# Staff Report

## Raleigh Appearance Commission Administrative Alternate Request

**Case File / Name:** AAD-3-20 – 5101 Capital Boulevard

**Request:** The applicant requests administrative alternates for UDO Section 1.5.6. Build-to and 1.5.8. Pedestrian Access.

**C2.00**

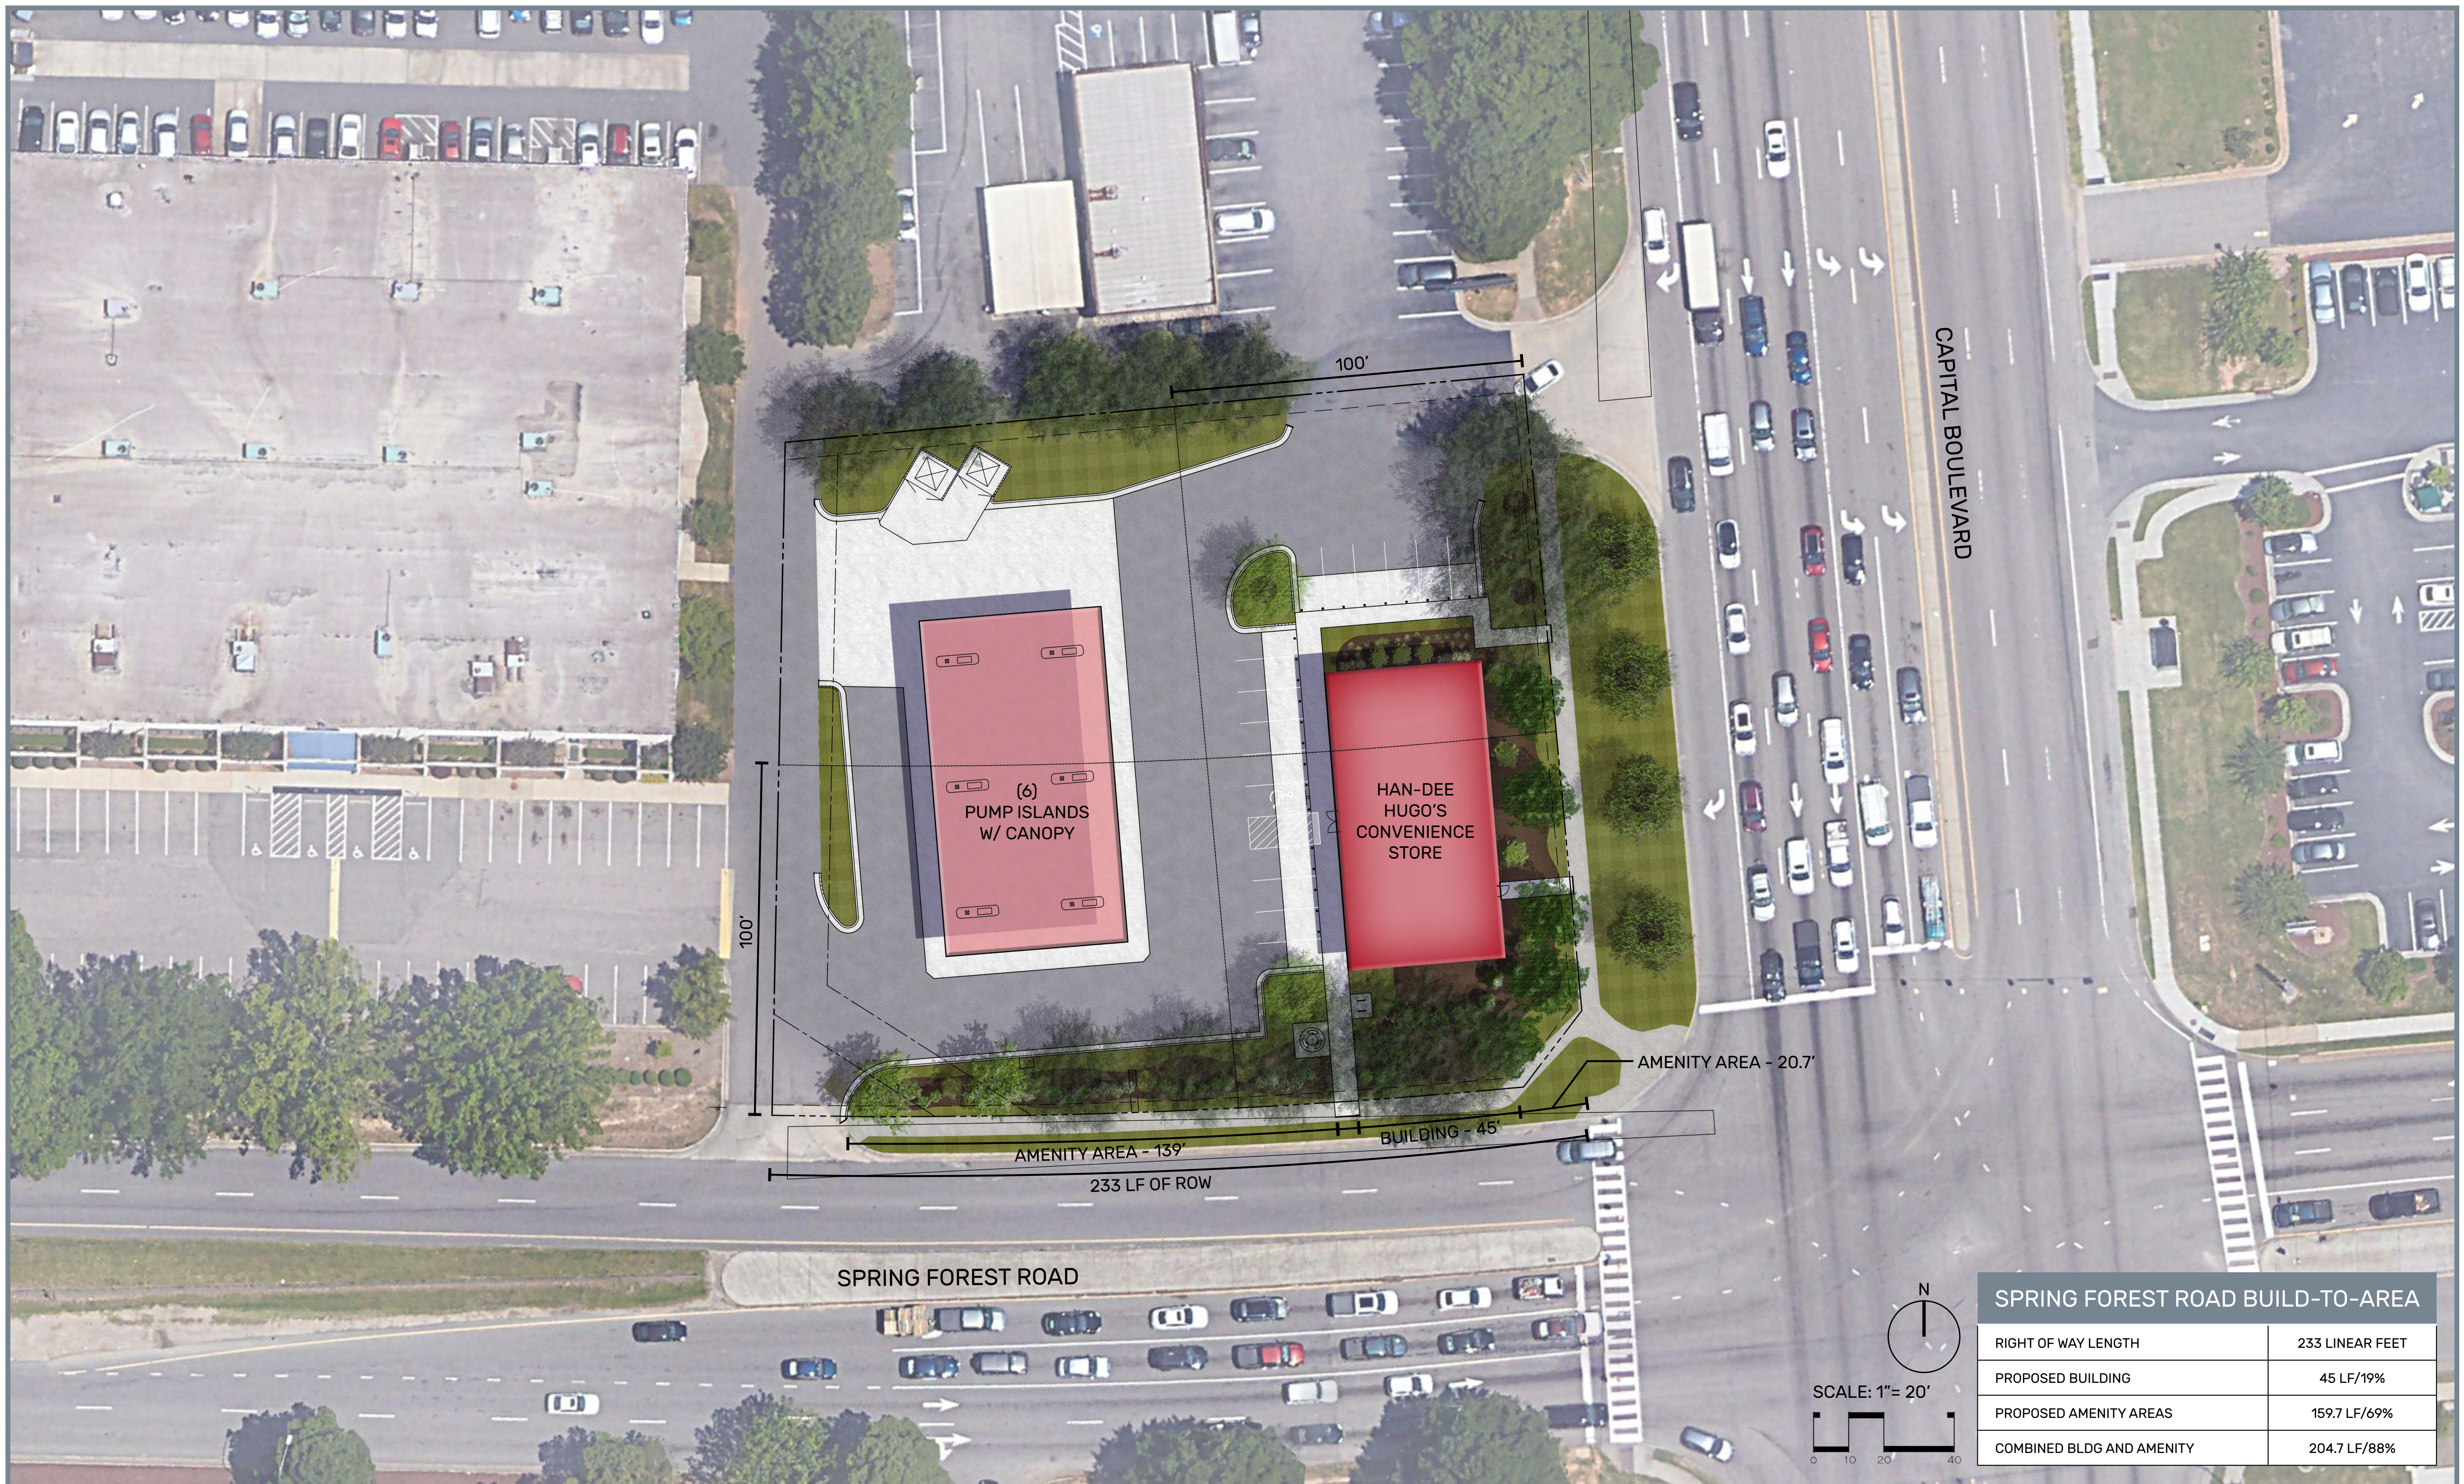
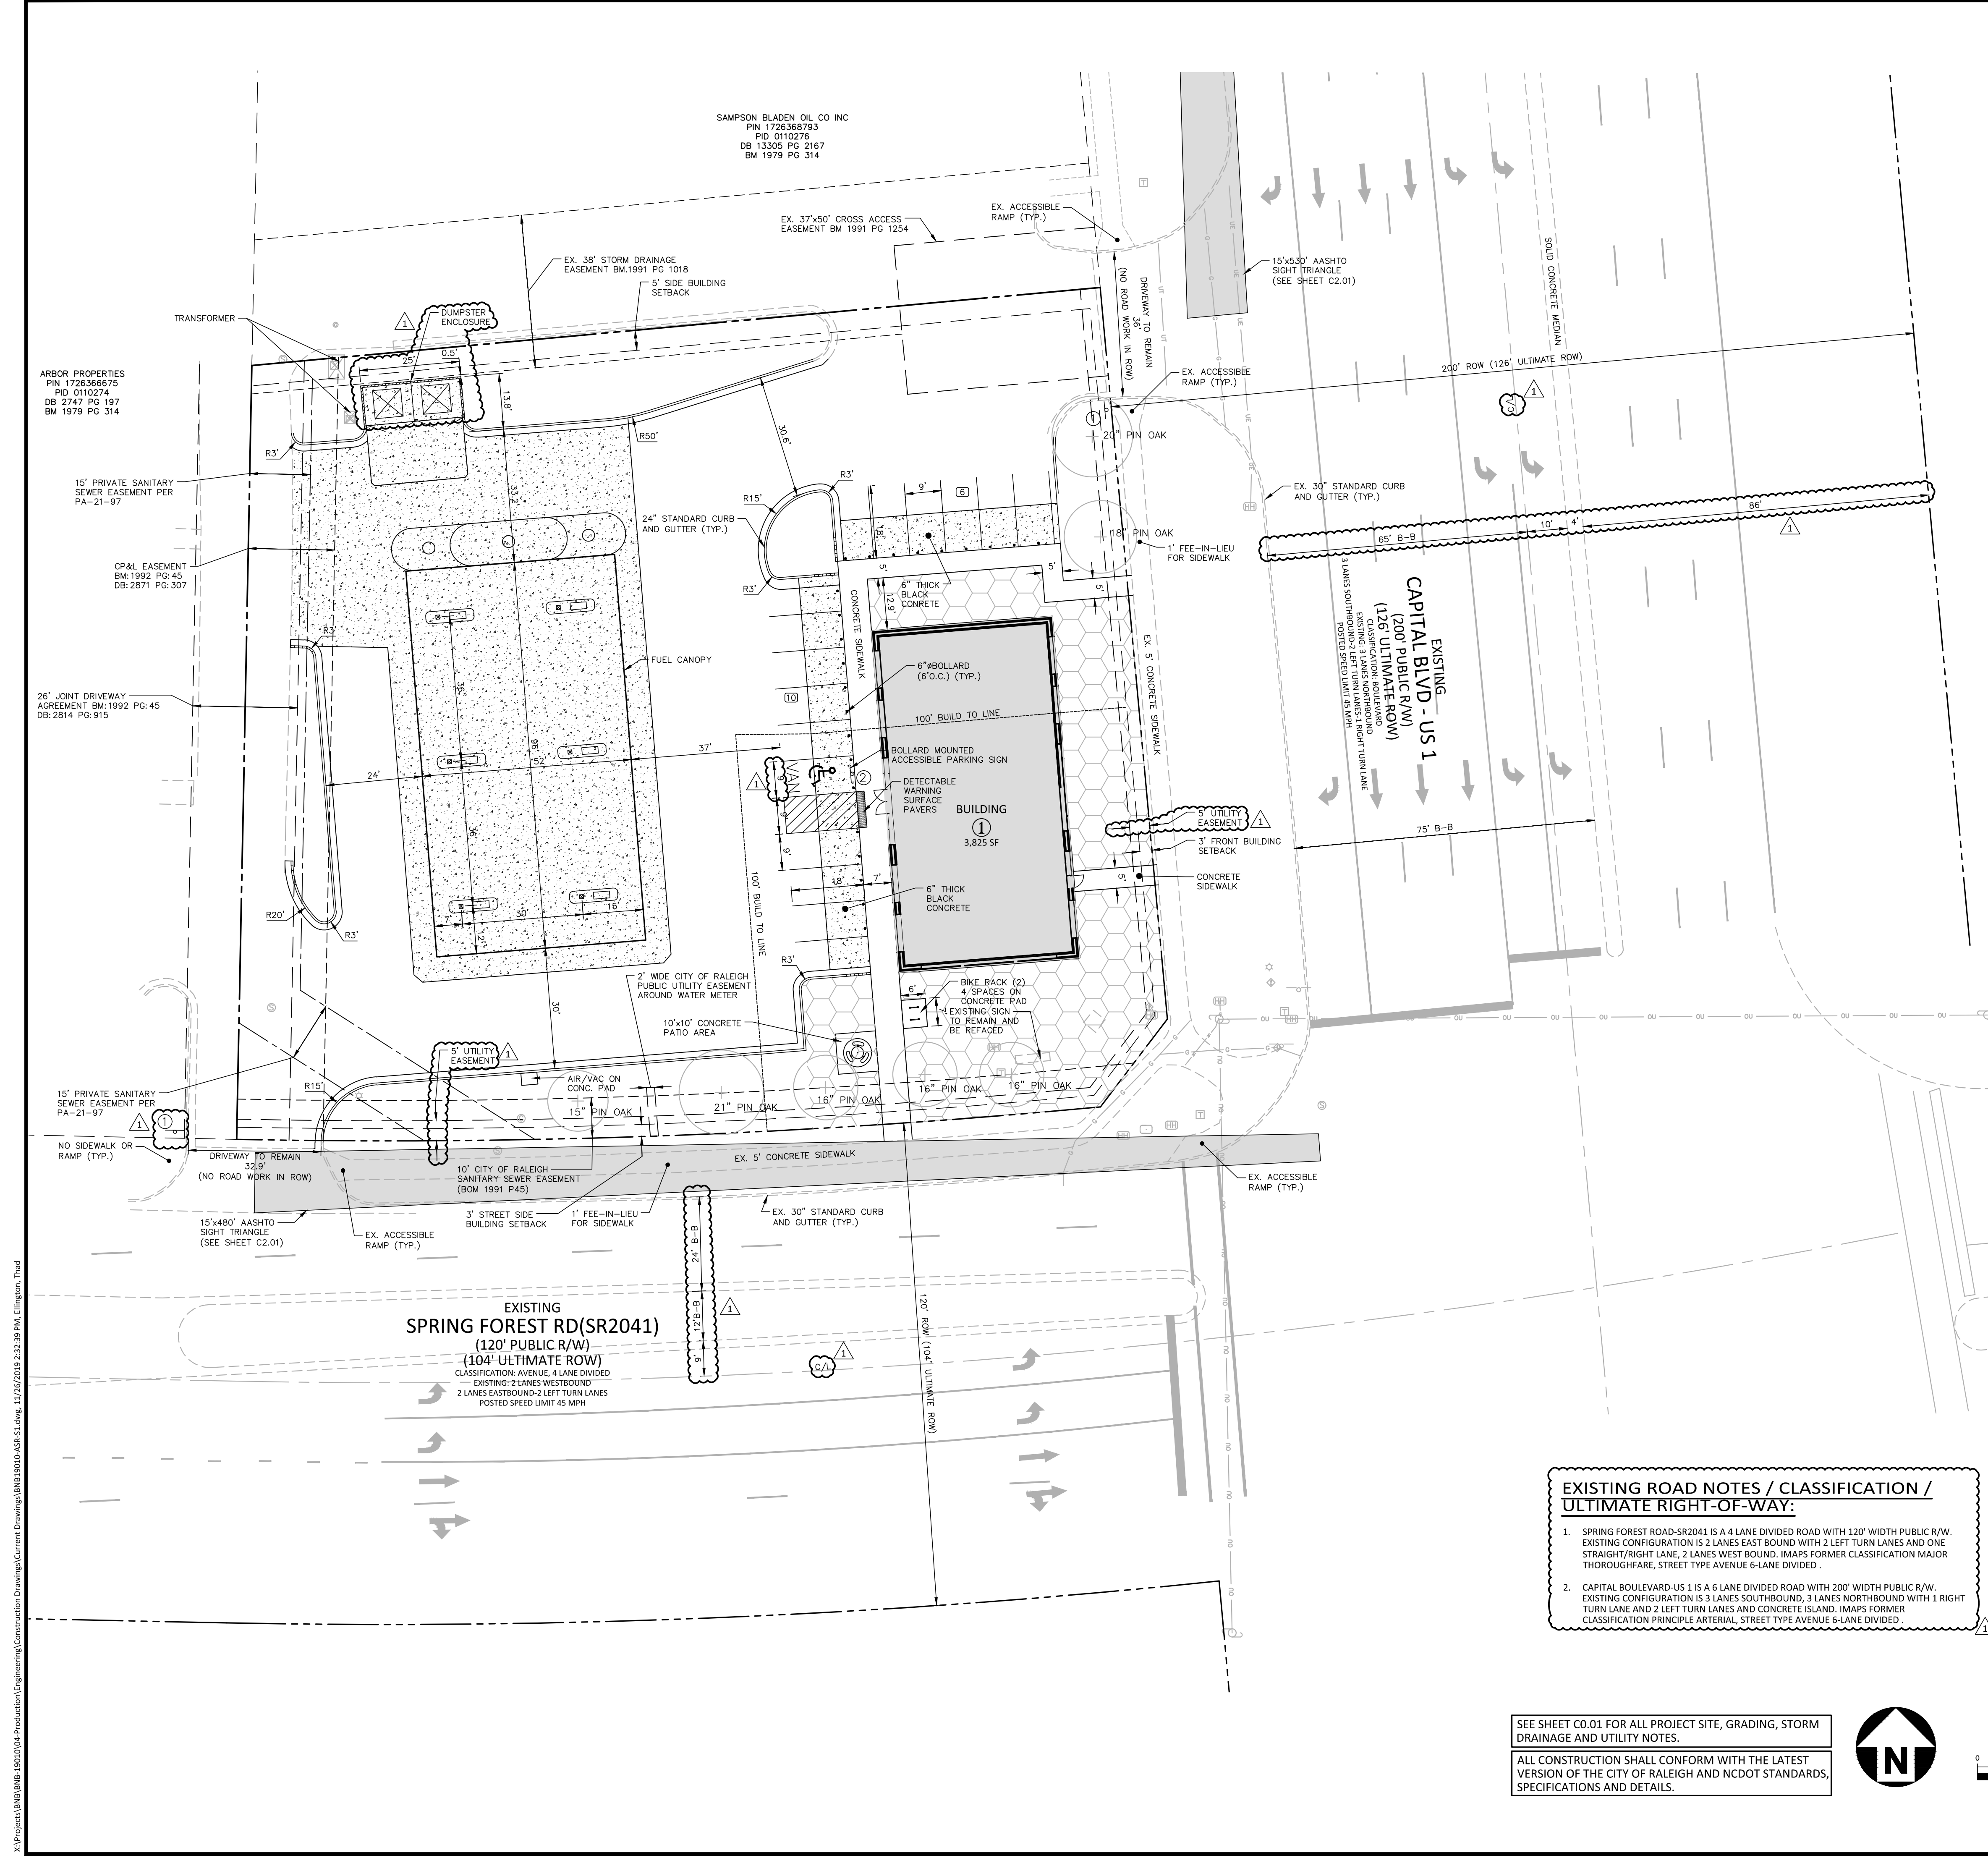
The applicant is proposing to develop gas station within an Industrial Mixed Use, 3 Story, Parking Limited Frontage (IX-3-PL) zoned district. Since the site has a Parking Limited frontage and a General Building type, the build-to is 50% of the lot width between 0'-100' of the primary street. Both Capital Boulevard and Spring Forest Road have been designated as Primary Streets. As proposed, the building meets the build-to for Capital Boulevard but is too small to meet the primary street build-to for Spring Forest Road, occupying only 22.1%.

The applicant is proposing an amenity area along Spring Forest Road that will include landscaping, picnic areas, and sidewalk access to the right-of-way. With the amenity area included, the combined building and amenity area will occupy 88% of the build-to.

**McAdams Response: The proposed building is within the build-to area of both corridors. The designation of Spring Forest as a second primary street requires double the building depth which is not feasible for redevelopment on this site. The proposed building location is pulled to the street and meets the intent of the build-to pattern.**

5. Site area that would have otherwise been occupied by buildings is converted to an outdoor amenity area under Sec. 1.5.3.B.  
**McAdams Response: The area along Spring Forest within the reduced built-to width will be redeveloped with an ADA-accessible amenity area which will include landscaped areas and a picnic table, and sidewalk access to the ROW and building.**

SPRING FOREST ROAD BUILD-TO-AREA	
RIGHT OF WAY LENGTH	233 LINEAR FEET
PROPOSED BUILDING	45 LF/19%
PROPOSED AMENITY AREAS	159.7 LF/69%
COMBINED BLDG AND AMENITY	204.7 LF/88%
